MEMORANDUM

To: Millbrook Village Planning Board
From: J. Choi, R. Chamberlin PE/PTOE
Subject: Bennett College Site Traffic Impact Study Review
Date: 28 September 2006
Cc: David Clouser

Figure 1: AM Peak Hour Through Volumes at the Two Access Points

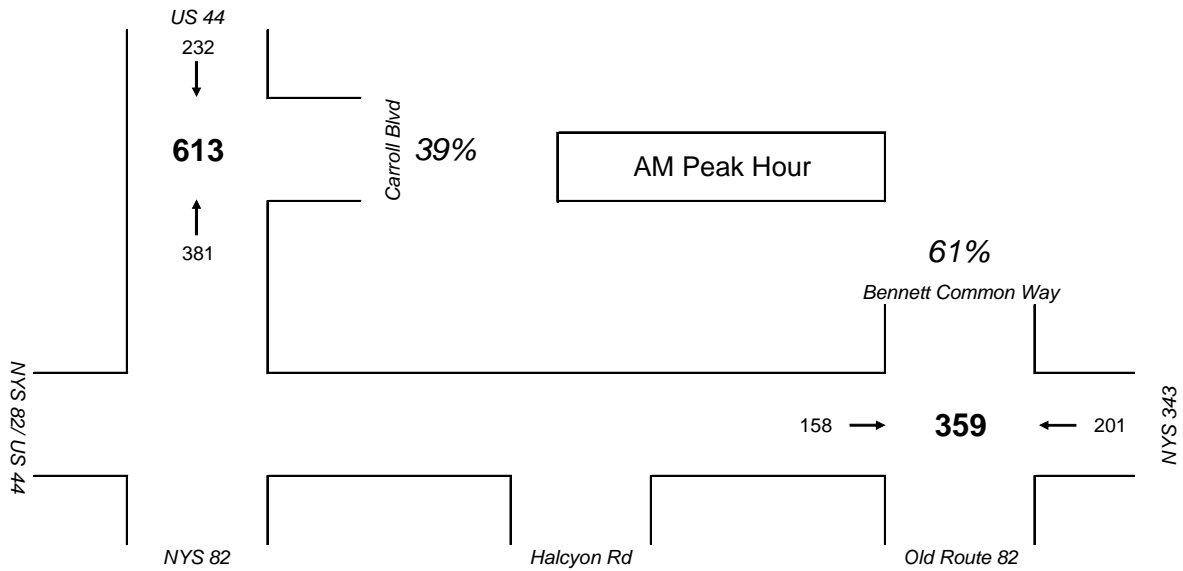
1. Based on the traffic counts performed for the traffic study, traffic at Carroll Boulevard is greater than traffic at Bennett Common Way (Figure 1-Figure 2). Further, it appears from the site plan that the development would have access to both streets. Thus, it would make sense if a greater proportion of the project's trips would use the Carroll Boulevard access point. The study currently has 61% of trips using the Bennett Common Way access point and 39% using the Carroll Boulevard access point. The traffic study suggests that "existing traffic patterns" were utilized to develop arrival and departure patterns, but the traffic data do not necessarily lead to this conclusion.

2. As shown in Figure 1 and Figure 2, the use of each access drive by site traffic is the same for the AM and PM peak periods. This is usually not the case with housing developments. Without a stronger rationale, it is difficult to say if this assumption is reasonable.
